Application No. 10/731,420

Preliminary Amendment dated October 26, 2005

AMENDMENT TO THE FIGURES:

Fig. 1

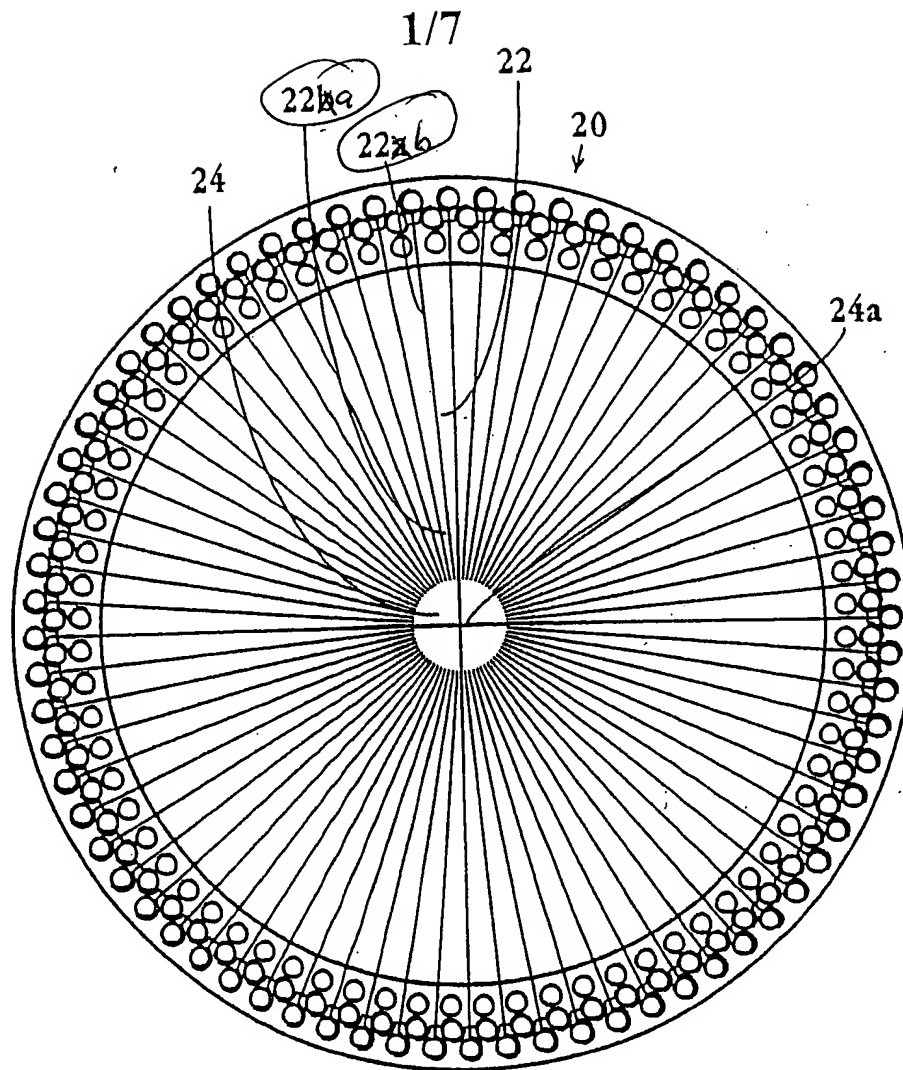
In order to correct inadvertent typographical errors, Applicants have amended Fig. 1 and Fig. 2. The amendment to the drawings changes the designation “22a” to “22b” and “22b” to “22a” in Fig. 1 and “22a” to “22” in Fig. 2. These changes should be recognized as obvious typographical errors by one of skill in the art looking at the figures in conjunction with the description in the specification. The changes make the specification consistent.

Support for the changes is as follows. Page 7, lines 20-23 recites that “The central reservoir region 24 . . . is in fluid communication with the proximal ends.” Thus, “22a” is the proximal end of microchannel 22. The specification further states at Page 7, lines 25-28, “In the embodiment shown in Fig. 3, each microchannel terminates at its **distal end** with three channels 26a, 26b. . .”. (emphasis added) The specification at page 7, lines 17-18 also recites, “Each microchannel includes a proximal end 22a and a distal end 22b. Therefore, in Fig. 1, the designation in the figure should be amended to show the proximal end as “22a” and the distal end as “22b.” Additionally, Applicants have removed the “a” from “22a” in Fig. 2 to be consistent with Fig. 1 and the specification.

The attached replacement sheet of drawings includes changes to Fig. 1 and Fig 2. The replacement sheet, which includes Figs. 1-3, replaces the original sheet including Figs. 1-3. Also attached is a copy of the original drawing sheet showing annotations in red ink that result in the changes incorporated in the replacement sheet.
